Access Compliance Report

Public Rights-of-Way

(Curb Ramps)

Intersection ID: 45629	Main Street: SARDIS_RD_NORTH	Cross Street: GALLERIA_BV	Location: SE
ADA ID: 036127C6E104	Ramp Type: PerpDiag	Initial Pass/Fail: Fail	Overall Compliance: No
Codes/Mitigation Info/Possible Solution		Field Measurements/Component Compliance	
Severity Score: 30

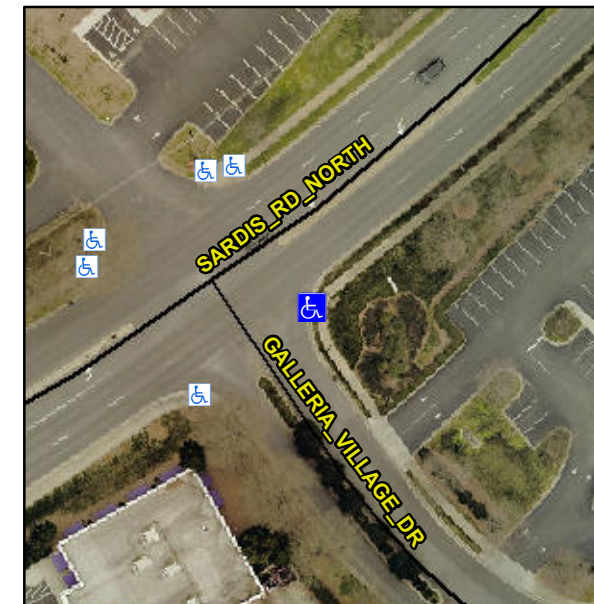
Not Found, R304.5.1, R304.5.3

Compliance	Description	Data	Compliance	Description	Data
N/A	Ramp Length (in)	96.0	Yes	Ramp Slope (%)	6.9
No	Ramp Width (in)	35.0	No	Ramp XSlope (%)	6.1
N/A	Flare Type LT	N/A	N/A	Flare Type RT	N/A
N/A	Flare Slope LT (%)	N/A	N/A	Flare Slope RT (%)	N/A
N/A	Flare Traversable LT?	N/A	N/A	Flare Traversable RT?	N/A
N/A	Landing Length (in)	N/A	N/A	DWS Provided?	N/A
N/A	Landing Width (in)	N/A	N/A	DWS Contrast?	N/A
N/A	Landing Slope (%)	N/A	N/A	DWS Length (in)	N/A
N/A	Landing X Slope (%)	N/A	N/A	DWS Full Width?	N/A
N/A	Landing Curb? (Y/N)	N/A	N/A	DWS Offset (in)	N/A
N/A	Shared Landing?	N/A			
N/A	Gutter Ponding?	N/A	N/A	Gutter Slope (%)	N/A
N/A	Gutter Lip Ht (in)	N/A	N/A	Gutter X Slope (%)	N/A
N/A	Painted X Walk1?	No	N/A	Painted X Walk2?	No
	X Walk 1 Direction	To N		X Walk 2 Direction	To SW
N/A	X Walk 1 Width (in)	N/A	N/A	X Walk 2 Width (in)	N/A
	X Walk 1 Slope (%)	0.8		X Walk 2 Slope (%)	1.2
	X Walk 1 X Slope (%)	0.7		X Walk 2 X Slope (%)	1.0

Remove & Replace Curb Ramp With Two New Directional Ramps or Equivalent.
